**TO: PROSPECTIVE BIDDERS** **DECEMBER 10, 2021**

**RE: IFB-6711 – NEW CONSTRUCTION OF COMMUNITY SCHOOL 35**  
**ADDENDUM NO. 4 - CITY RESPONSE TO REQUESTS FOR INFORMATION AND CLARIFICATIONS**

**1 BASEMENT POWER AND FA PLAN**  
E300

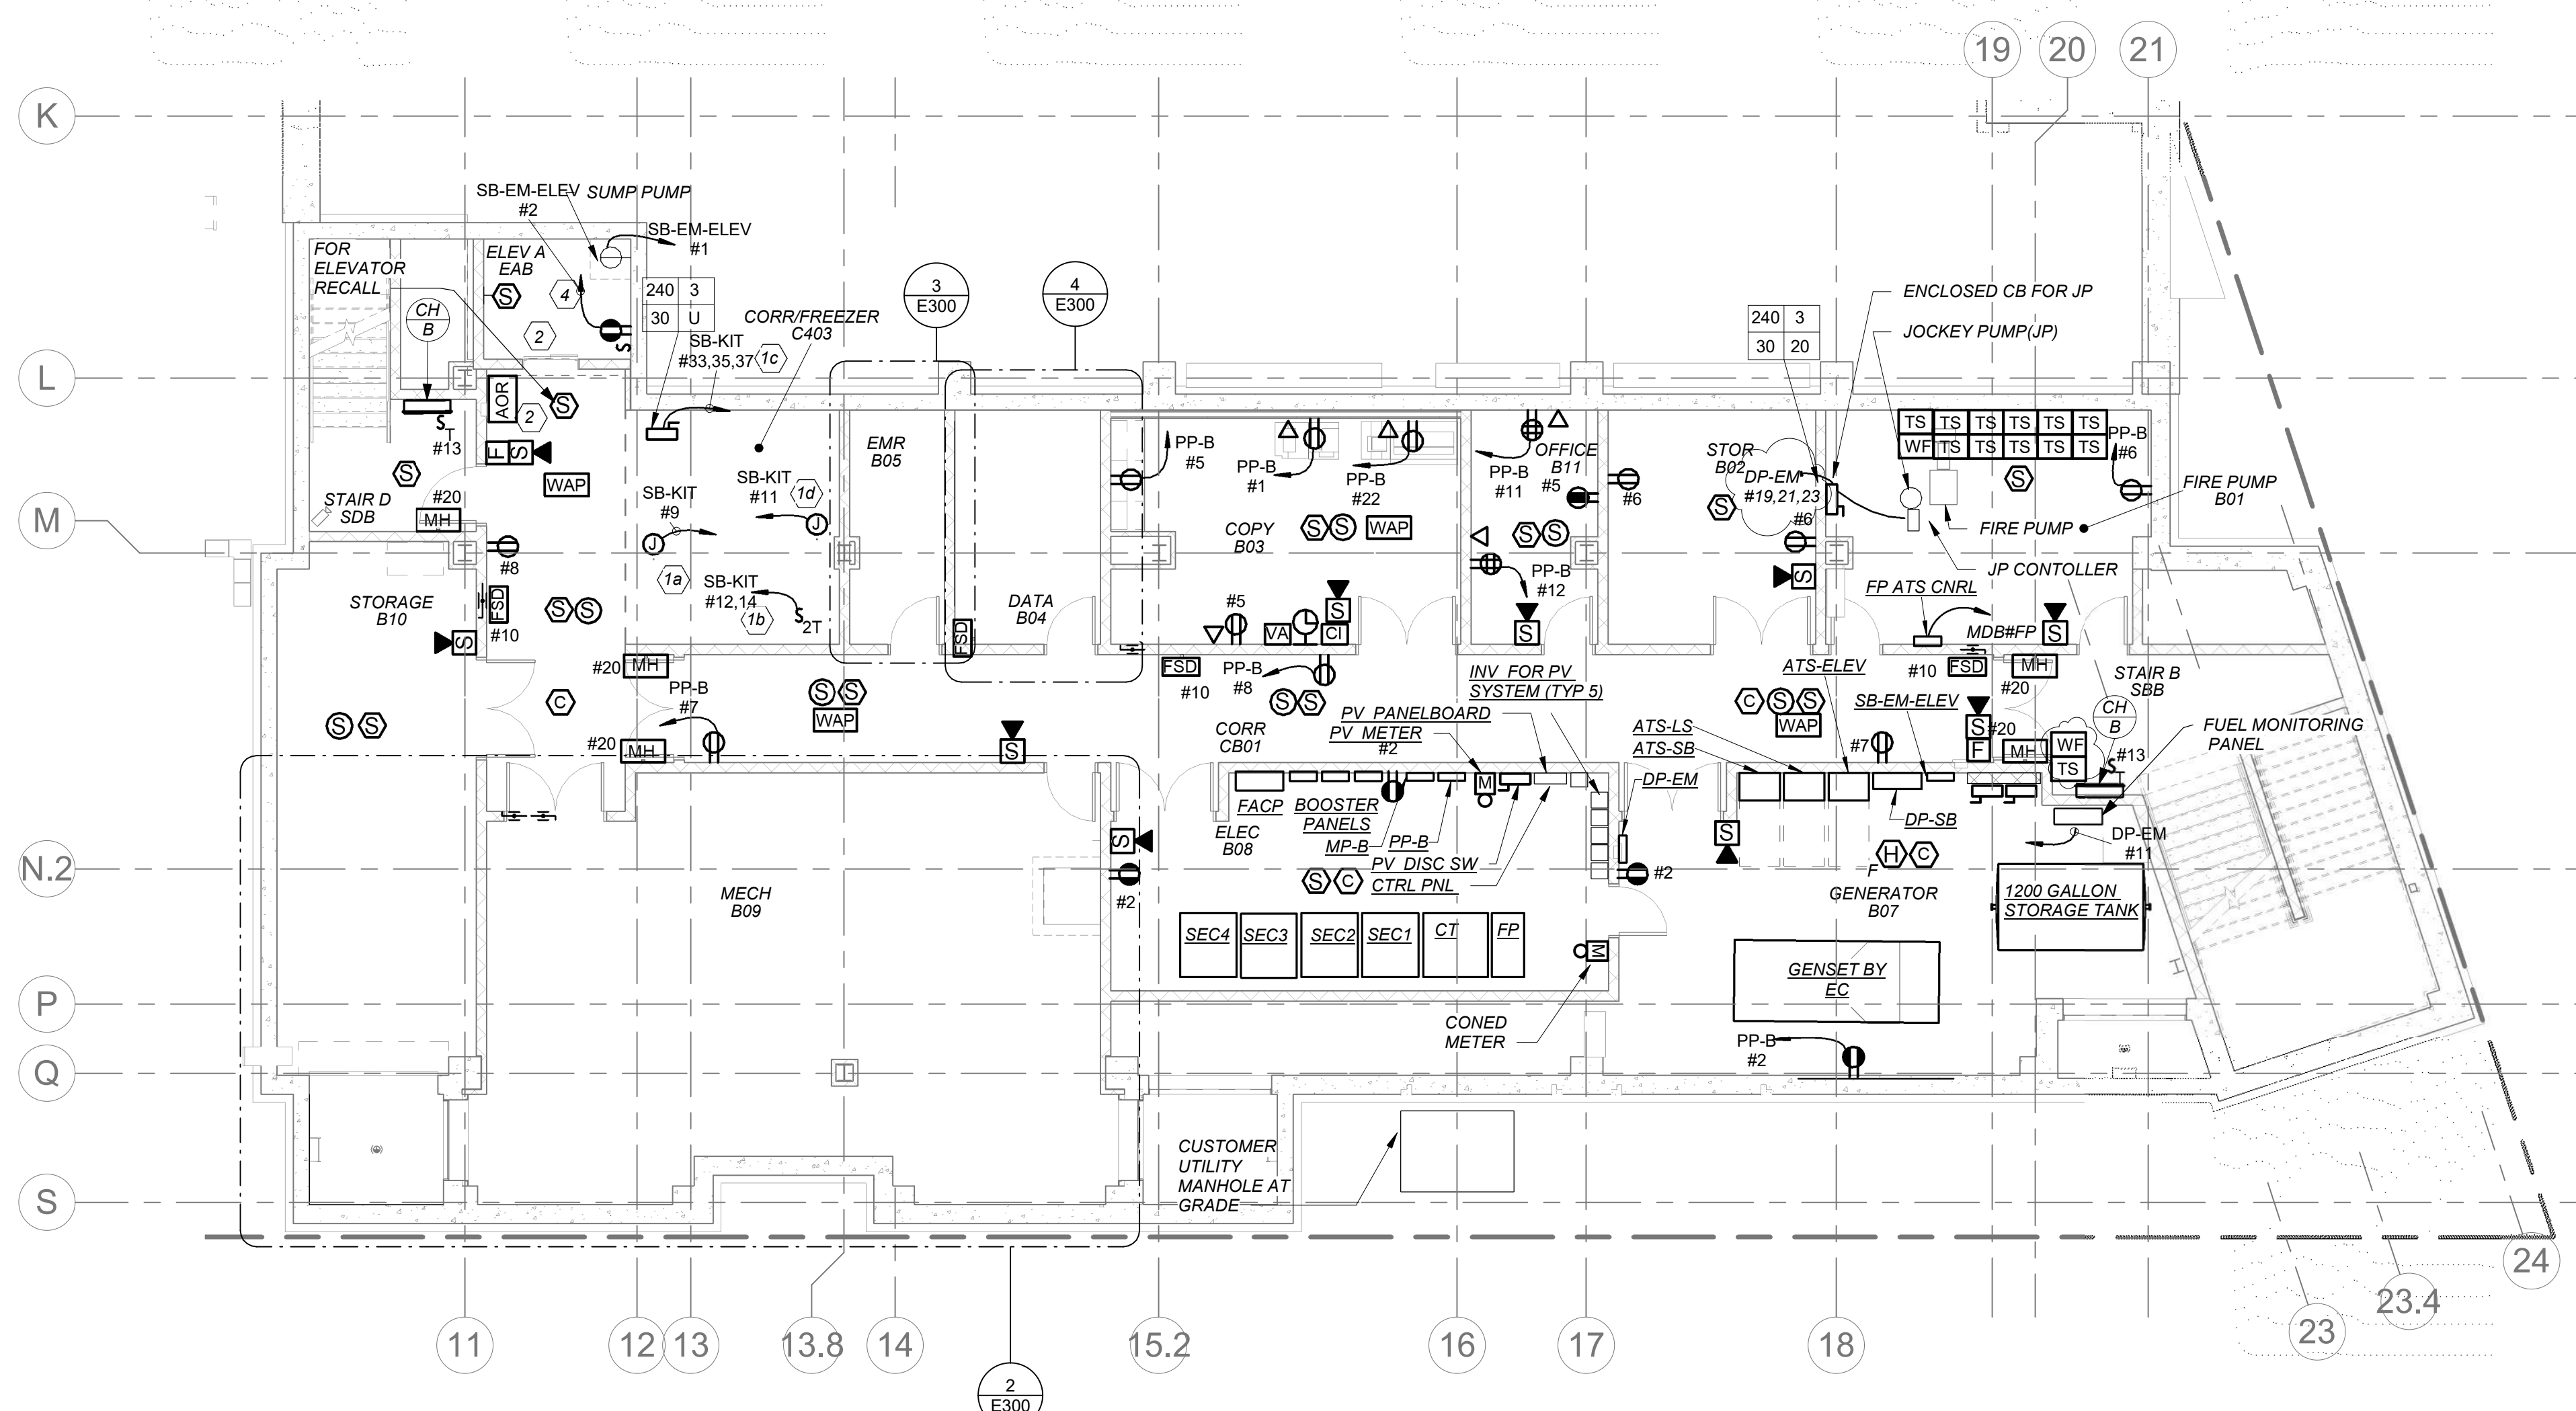
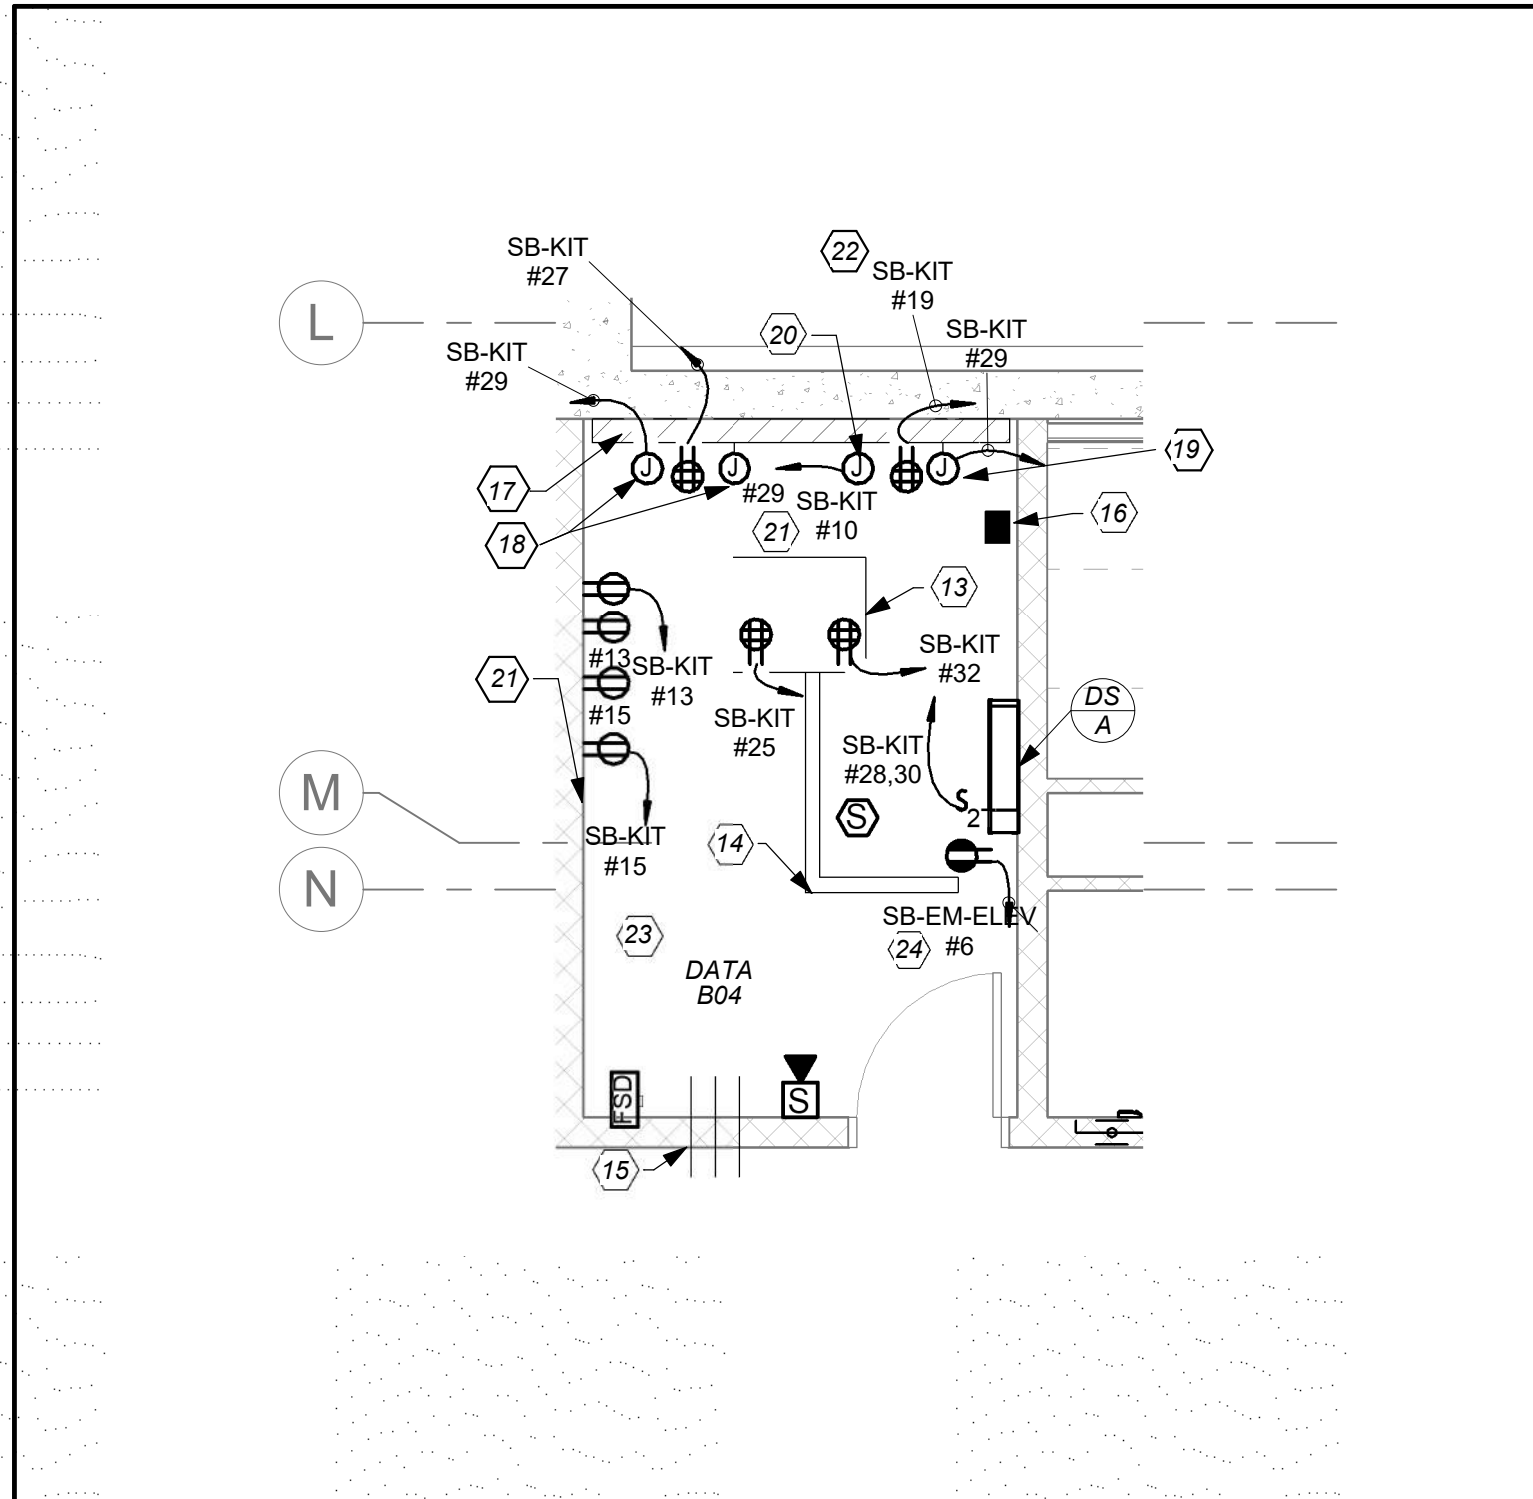
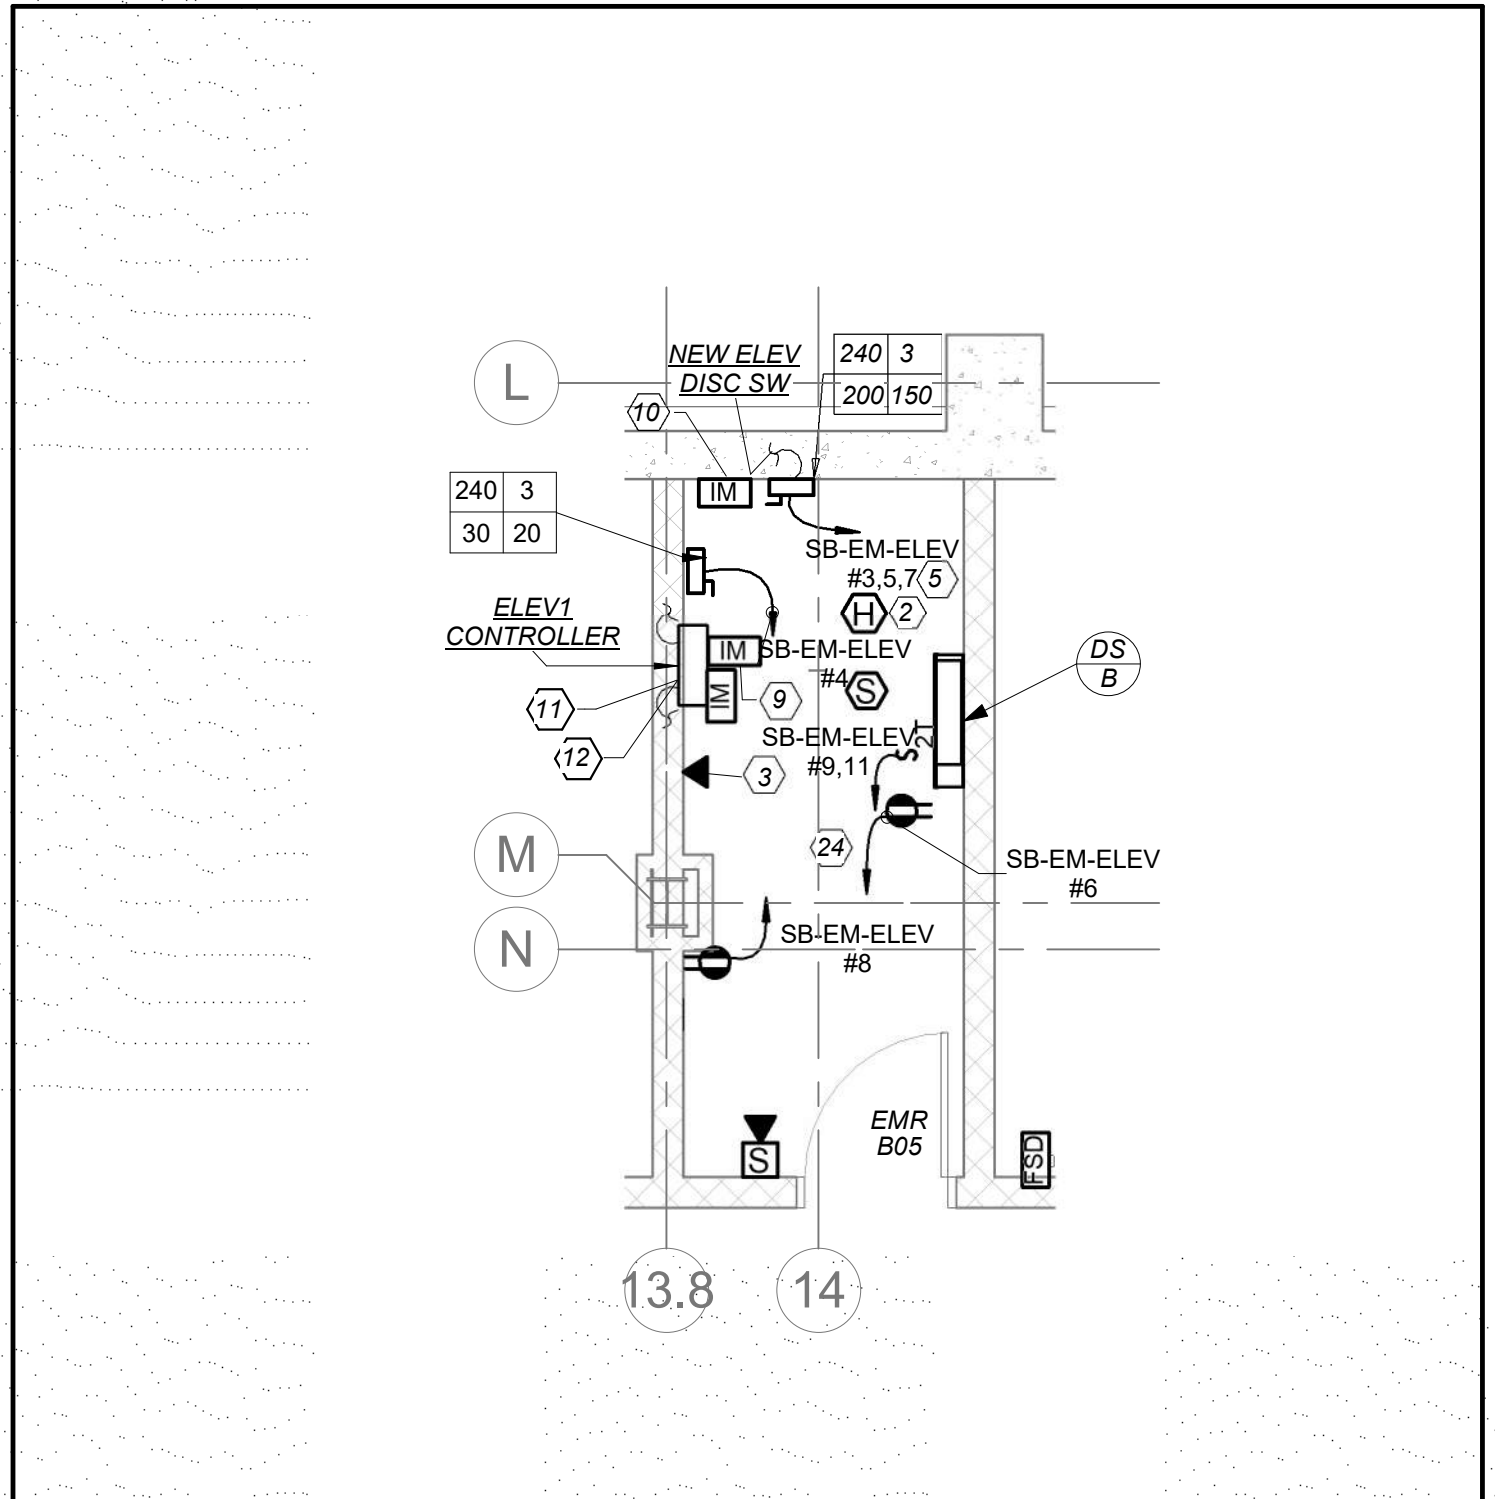
**18. DRAWING E300 – BASEMENT POWER AND FA PLAN**

1. Relocate water flow and tamper switch in Stair B SBB.
2. Jockey Pump circuit changed to panel board DP-EM. Provide 20amp-3P CB with 3#12+1#12 -3/4”C.
3. Sump Pump Control panel location shown the drawing.
